Neighbor comment on demolition and replacement of single-family house at  
69 Charlotte Street. 19-0284CA

Sunlight Reduction of Proposed House at  
 69 Charlotte St

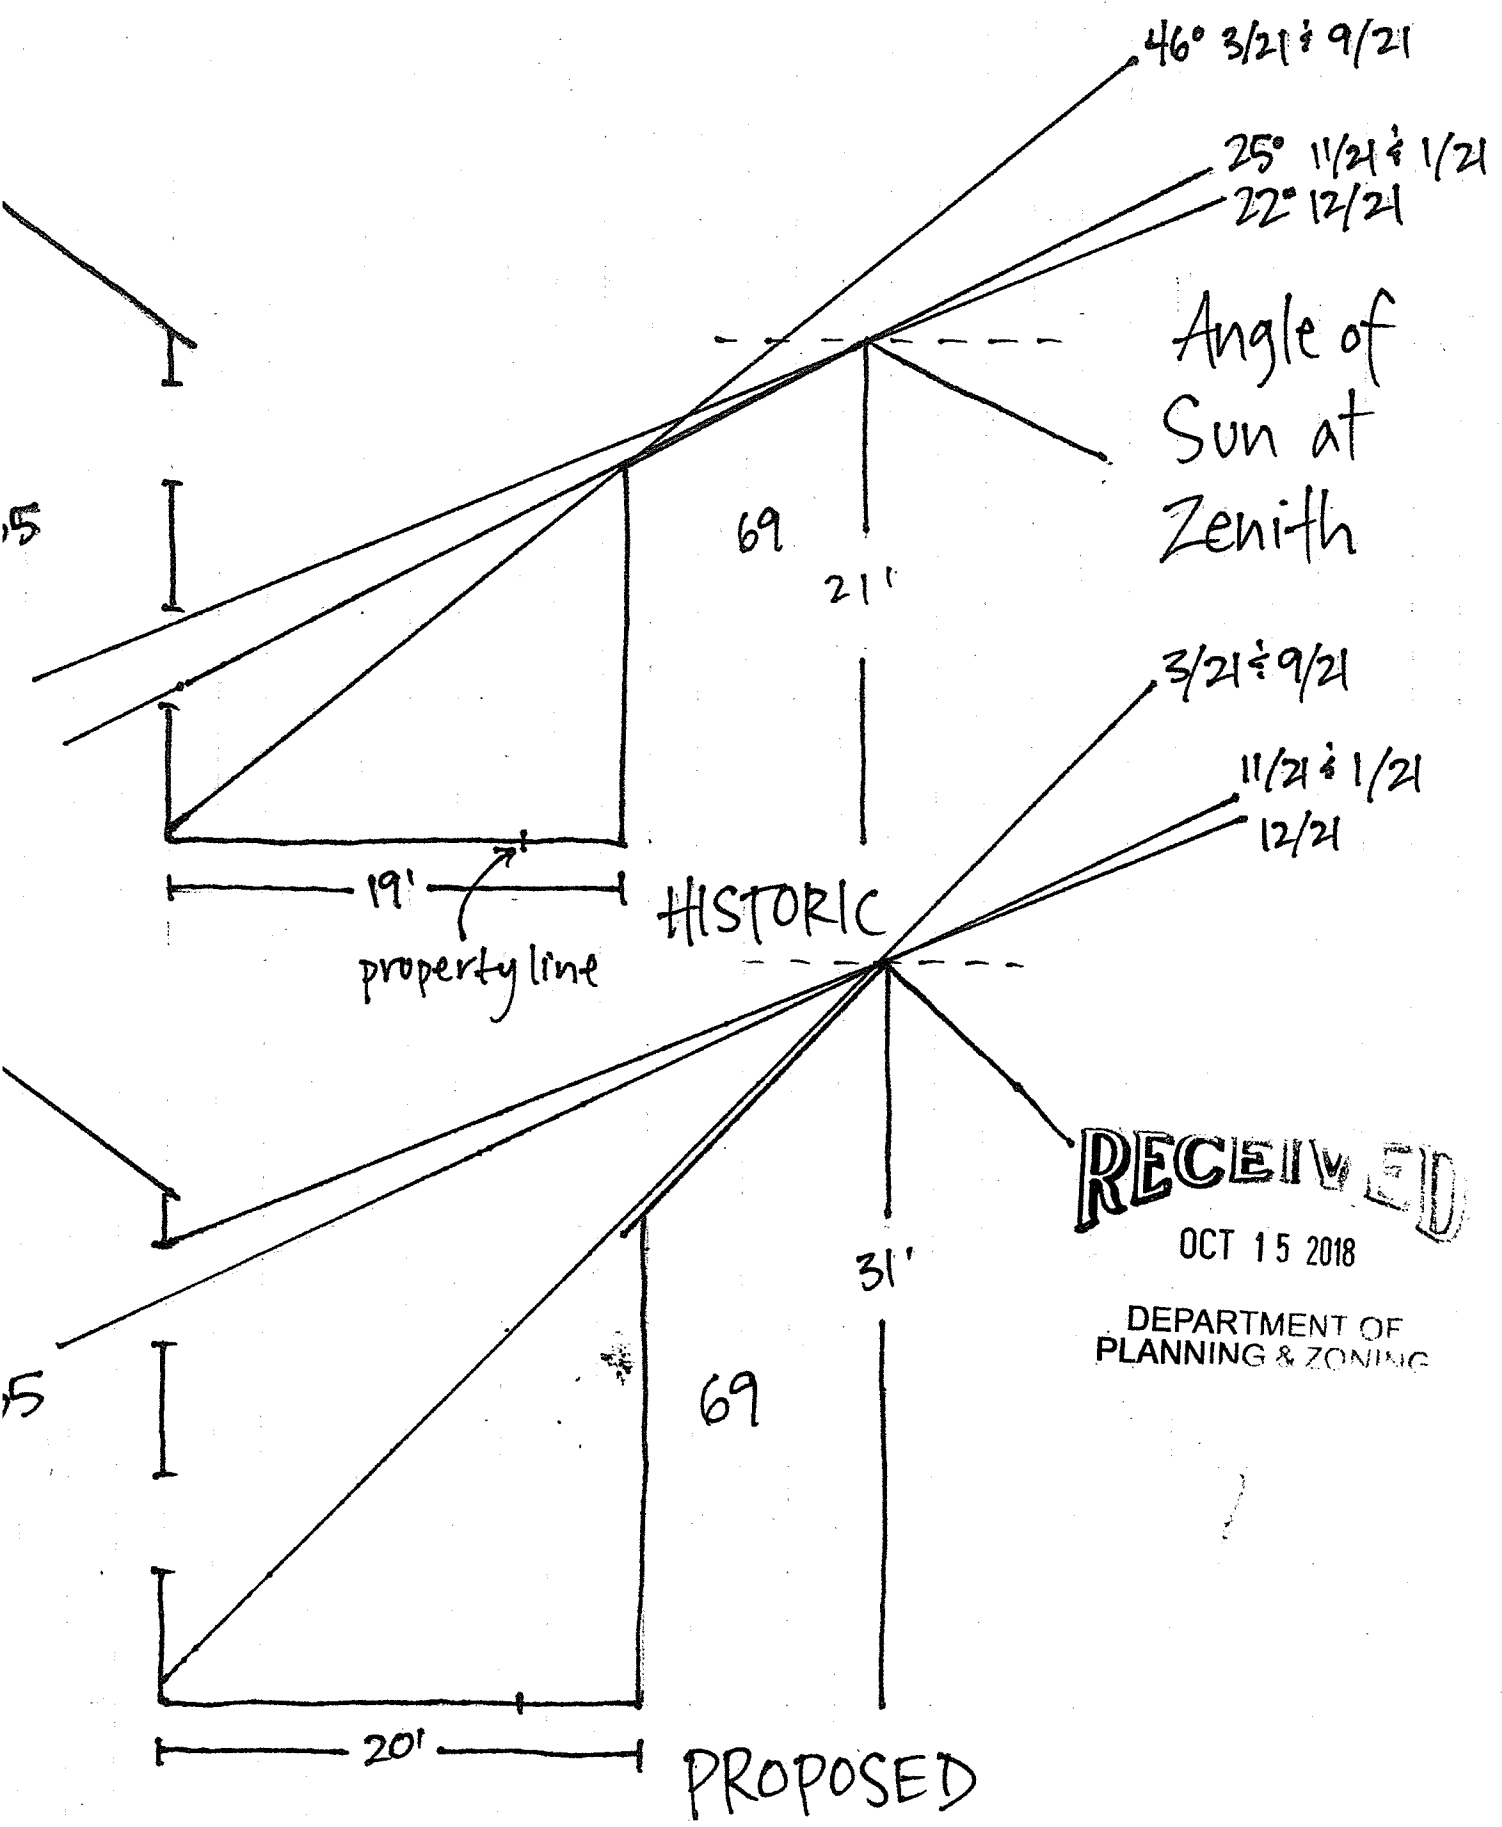
I am troubled and deeply saddened to realize that the proposed new structure with its much higher and longer ridgeline will forever block southern light from our ground floor from October through February. According to calculations based on the angle of the sun at solar noon, the height of the proposed ridgeline (estimated to be 31'), and the distance between the ridgeline and our windows, the last and first days that sunlight will reach our kitchen windowsill are October 6 and March 7.

I have included a diagram that shows the angle of the sun over the course of the year comparing the shadows cast by the current, historic structure and the proposed structure. I have estimated the height of the current structure at 21'. The plans available to me for the proposed structure do not label the height of the ridgeline, but with measurement, I have estimated it to be 31'. Please bear in mind that the lines represent the height of the shadow cast by the structure at 69 Charlotte upon our south wall and windows at the sun's zenith for the date. For most hours of those dates, the sun is lower and the shadow higher.

I recognize that the plans for the proposed house fit the neighborhood character, and that it is not much taller than other homes on the street, including ours. In the 1920's, when Edward Paya built both 65 and 69 Charlotte Street, he deliberately made 69 shorter to allow greater southern exposure for 65. I have no complaint about the fact that the lot coverage far exceeds the zoning guidelines for our low-density neighborhood. It seems that the excessive coverage is determined by the current structure; it follows that the current height should also have bearing on the proposed house. I recognize that the plans are designed to maximize square footage and southern exposure at 69 Charlotte, but unfortunately this is done at our expense. While our future neighbors are within their legal rights to build this new home, I beseech them and their architects to reconsider the design. I have reached out to the owners with our concerns and request. Perhaps the layout could be flipped in a mirror image to how it is currently drawn, placing their ridgeline further

from our home. Alternately, if the ridgeline were lowered by a few feet we would gain extra minutes and days of sunlight.

The loss of treetop views from our house over and around the much lower, historic roofline next door is something we can learn to live with. The loss of sunlight into the heart of our home feels devastating. Modifications to the design could help mitigate our losses. For 14 years, and our kids' entire lives, we have known the joy of winter sunlight in our home. It is precious to us. Please consider our request for a lower ridgeline on the proposed structure to be built at 69 Charlotte Street.
